**RESPONSE TO COMMENTS ON THE DRAFT FIELD SAMPLING PLAN (FSP) AND
QUALITY ASSURANCE PROJECT PLAN (QAPP), ADDITIONAL INVESTIGATION OF
ONSHORE INSTALLATION RESTORATION SITE 21, VESSEL WASTE OIL RECOVERY
AREA, DATED FEBRUARY 26, 2001
NAVAL STATION TREASURE ISLAND, SAN FRANCISCO**

This document presents the Navy's responses to comments from 1) the California Regional Water Quality Control Board (RWQCB), 2) the City of San Francisco (submitted by Geomatrix Consultants), and 3) Ms. Dale Smith RAB member, on the *Draft Field Sampling Plan (FSP) and Draft Quality Assurance Project Plan (QAPP), Additional Investigation of Onshore Installation Restoration Site 21, Vessel Waste Oil Recovery Area, Naval Station Treasure Island, San Francisco*, dated February 26, 2001, and prepared by Tetra Tech EM Inc. (TtEMI). The RWQCB comments were received on April 5, 2001 via electronic mail. The City of San Francisco comments were received on April 11, 2001 via electronic mail and the comments from Ms. Dale Smith were received on April 17, 2001 via electronic mail.

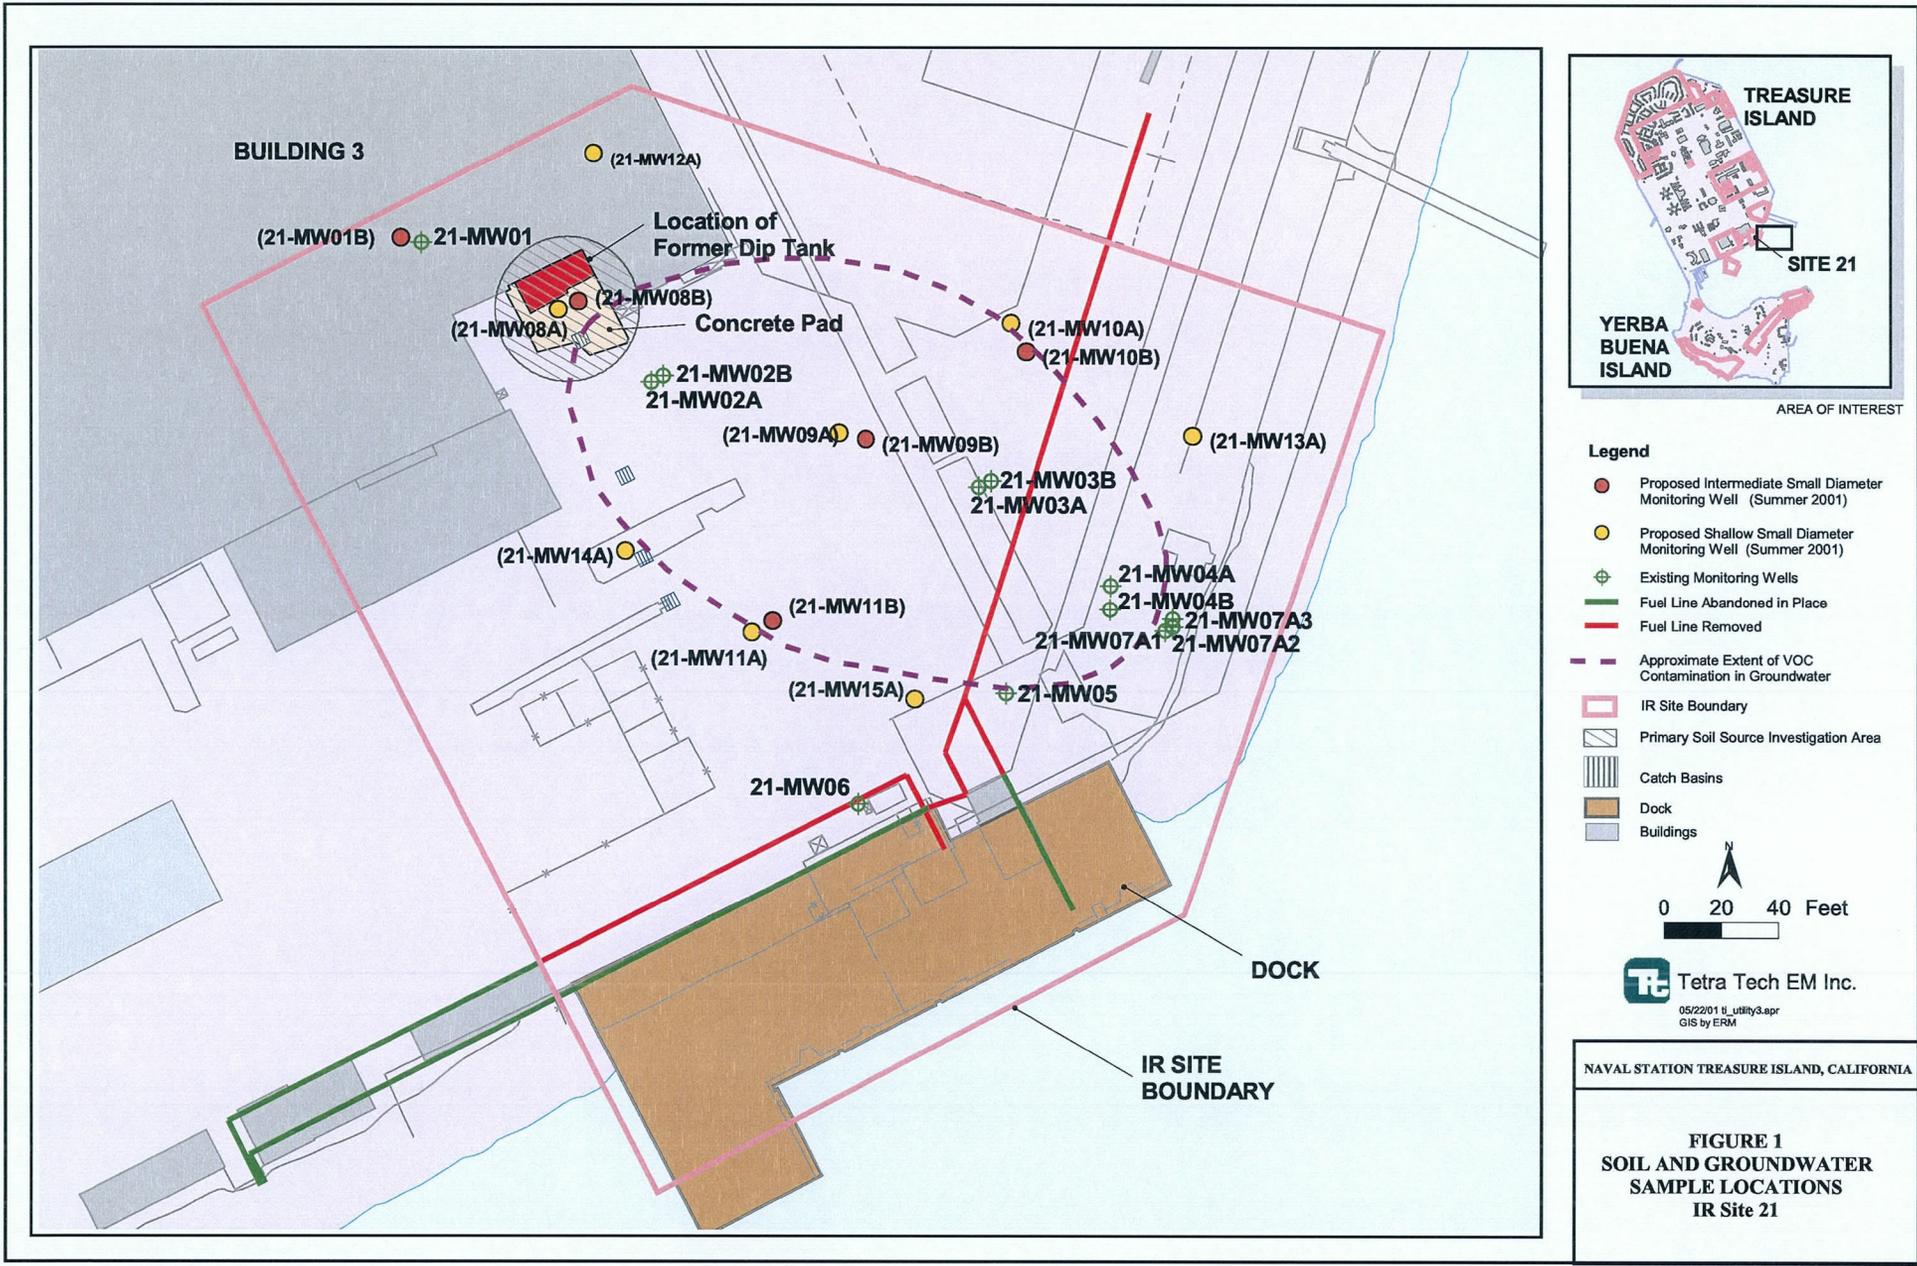
- 1e. Comment:** The locations of the proposed upgradient monitoring wells may need to be adjusted after the extent of VOCs in soil has been delineated.

- 1f. Comment:** Based on the distribution of tetrachloroethene (PCE), trichloroethene (TCE), and 1,2-dichloroethene (1,2-DCE) detected in the shallow and intermediate groundwater, the proposed monitoring well locations should be adjusted closer to the various VOC plumes. Let's discuss the rationale for the well locations before the next draft FSP is submitted.

- Response:** Comment noted. Well locations provided on Figure 1 are proposed only and are subject to relocation based on field data and utility clearance issues.

- Response: Monitoring well locations are proposed so that the horizontal boundaries (non-detect) of the plume can be positively identified. However, the location of the monitoring wells has been adjusted to be within the suspected plume boundary based on RWQCB's written and verbal comments. A revised figure is attached.
